HISTORIC AND DESIGN REVIEW COMMISSION

HDRC CASE NO: 2023-127
ADDRESS: 101, 103 PASO HONDO
LEGAL DESCRIPTION: NCB 591 BLK 4 LOT 13
ZONING: RM-4, H
CITY COUNCIL DIST.: 2
DISTRICT: Dignowity Hill Historic District
APPLICANT: ADRIAN VEGA/VECA DEVELOPMENTS LLC
OWNER: VECA DEVELOPMENTS LLC
TYPE OF WORK: Construction of two, 2-story residential structures
APPLICATION RECEIVED: April 05, 2023
60-DAY REVIEW: Not applicable due to City Council Emergency Orders
CASE MANAGER: Edward Hall

REQUEST:

Historic and Design Review Commission
Design Review Committee Report

SETBACK DIAGRAM

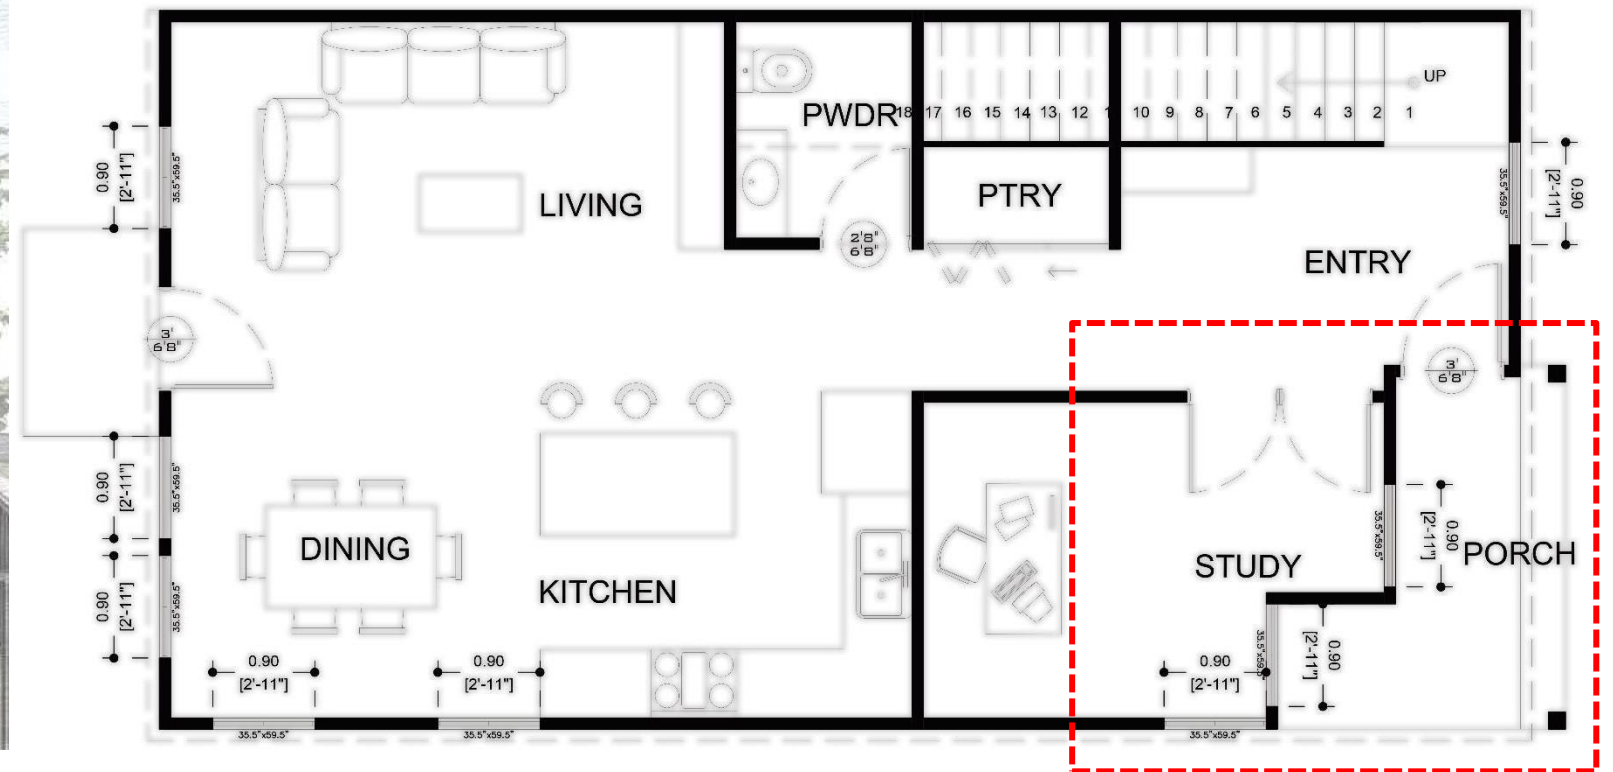
i. That an updated setback diagram should be submitted for review and approval that shows the proposed new construction in context with the historic structures on the block.

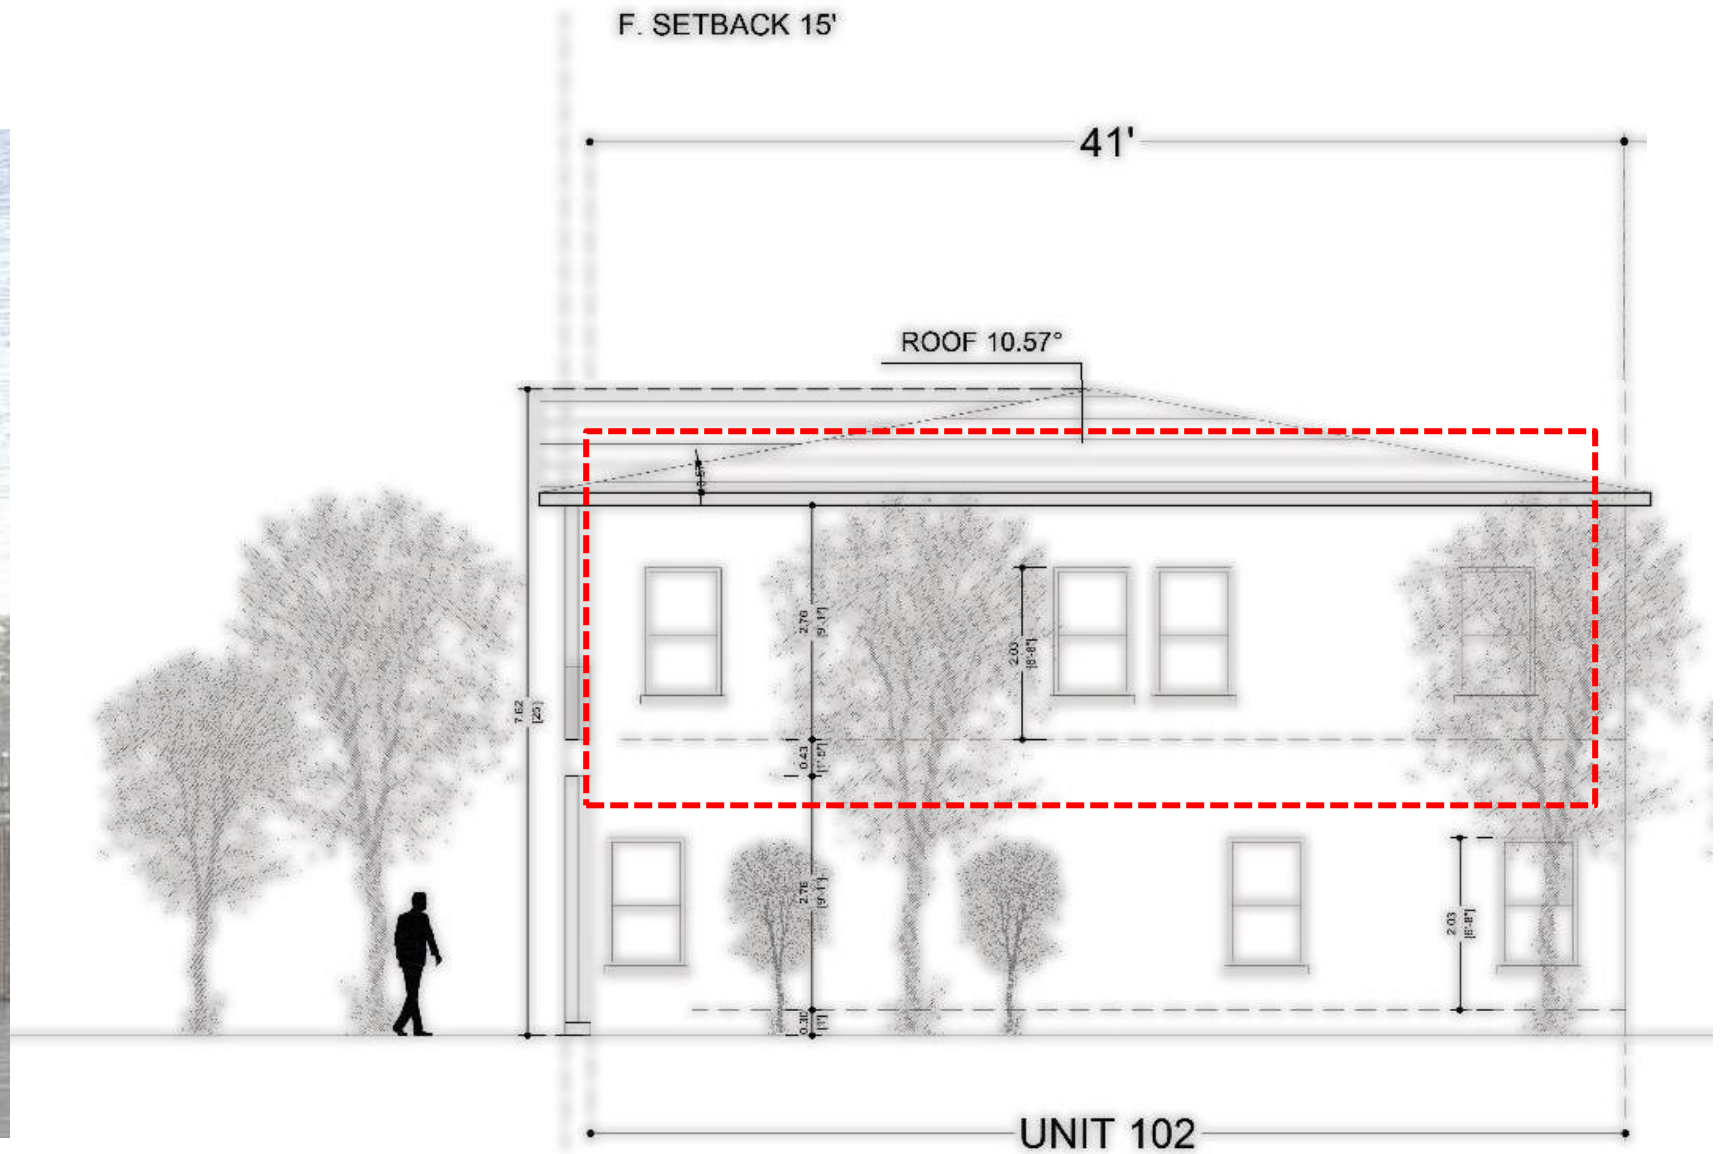
- ii. That additional porch and entrance elements be added to the southern structure. A wraparound porch or a porch that addresses both streets while being integrated into the massing of the overall structure should be incorporated into the design.

ELEVATION EAST
UNIT 102

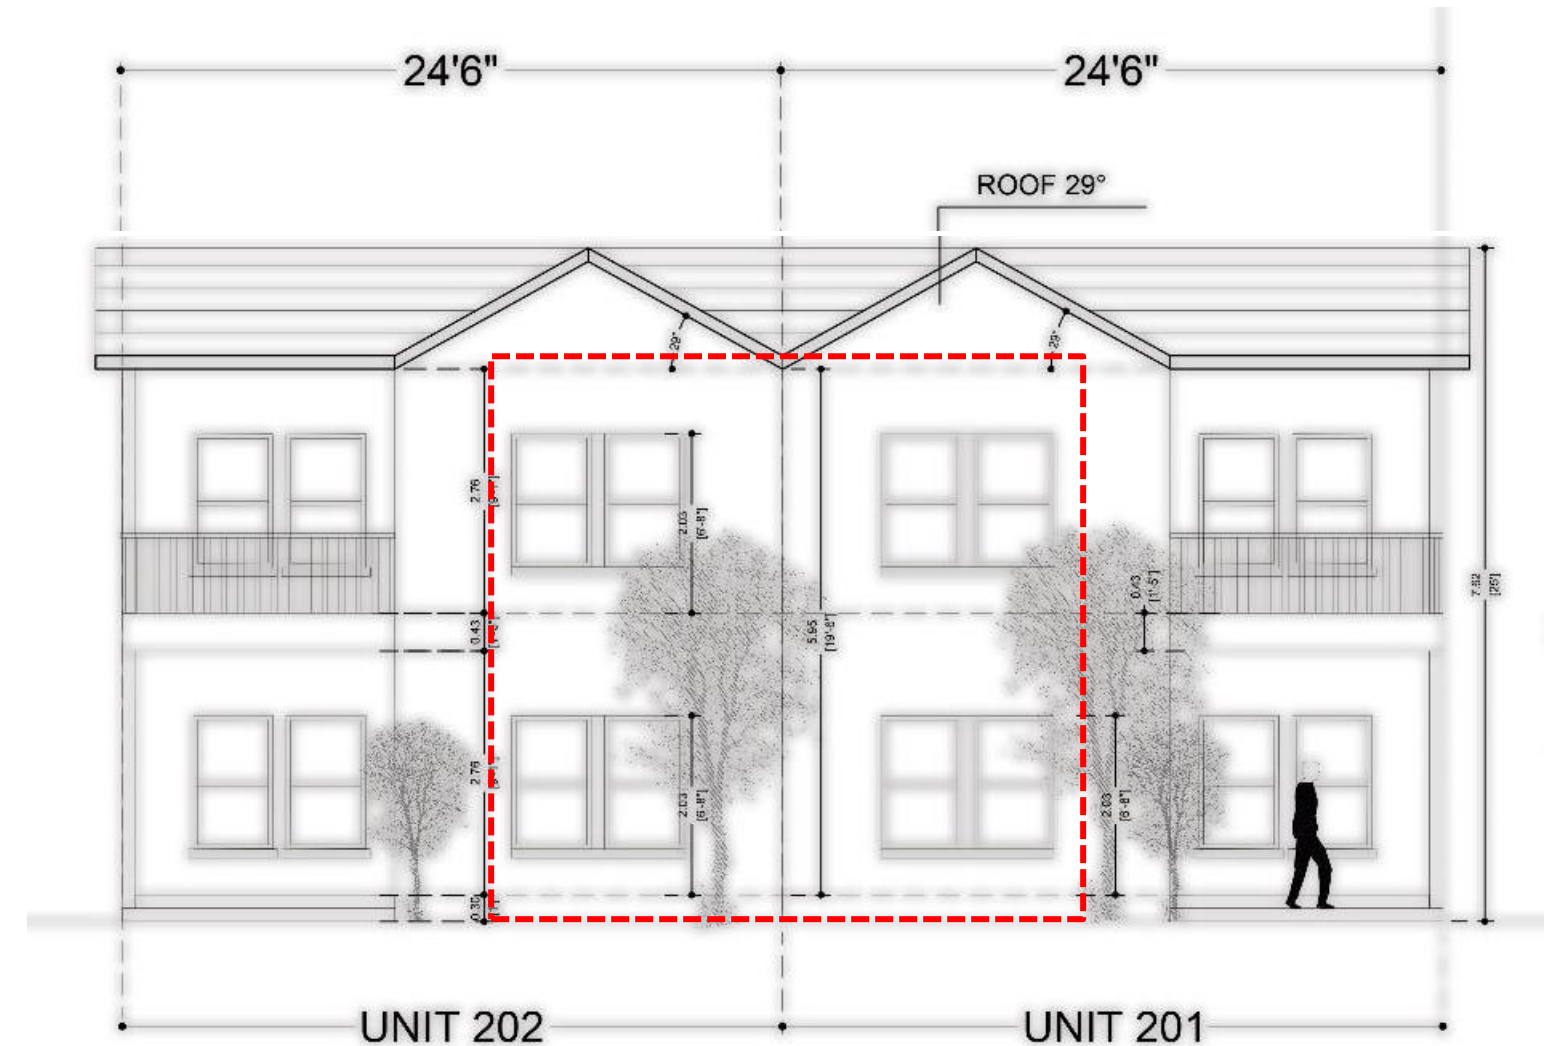
- iii. That the applicant install Windows on the second floor of the east facade of unit 102, which is currently void of fenestration.

PROPOSED MATERIALS

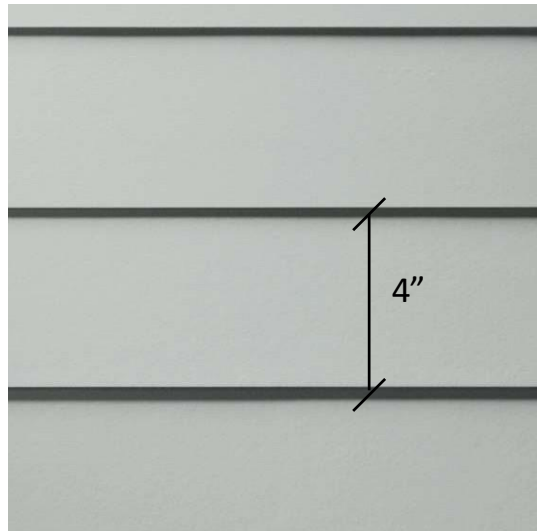
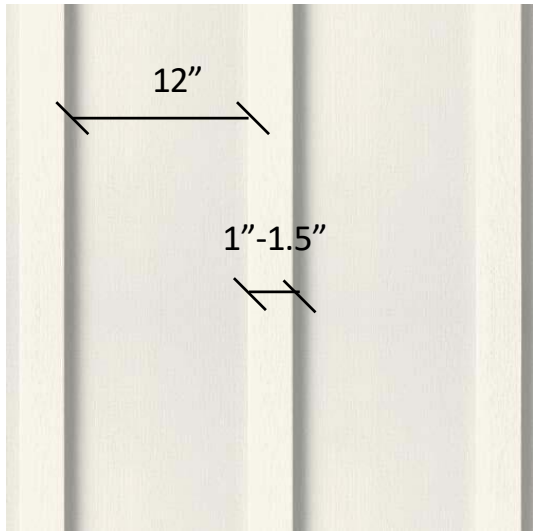
- p. **MATERIALS** – The applicant has noted the installation of fiber cement lap siding with a four (4) inch exposure, board and batten siding with boards that are twelve (12) inches wide with battens that are 1 to 1.5 inches in width, aluminum clad wood windows, steel entry doors, aluminum clad sliding glass doors and

- q. WINDOW MATERIALS – The applicant has noted the installation of aluminum clad wood windows. Staff finds that product specifications should be submitted to staff for review and approval that are consistent with the adopted policy guide for windows.
